"KEHREA"

Nature of Survey

2nd. S.S. No. 3.

THICKNESSES OF PLATING ascertained by drilling, and comparison of same with the original thicknesses.

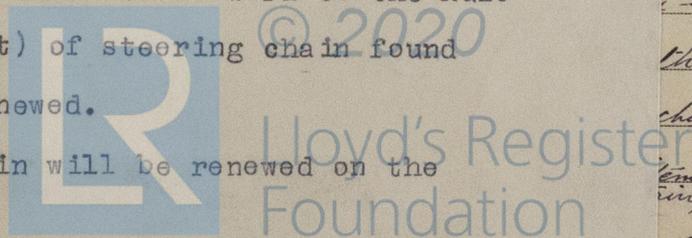
Drillings at ends made in the vicinity of the peak bulkheads.

The shell plating has been drilled, with results as shewn above, which appear to be satisfactory.
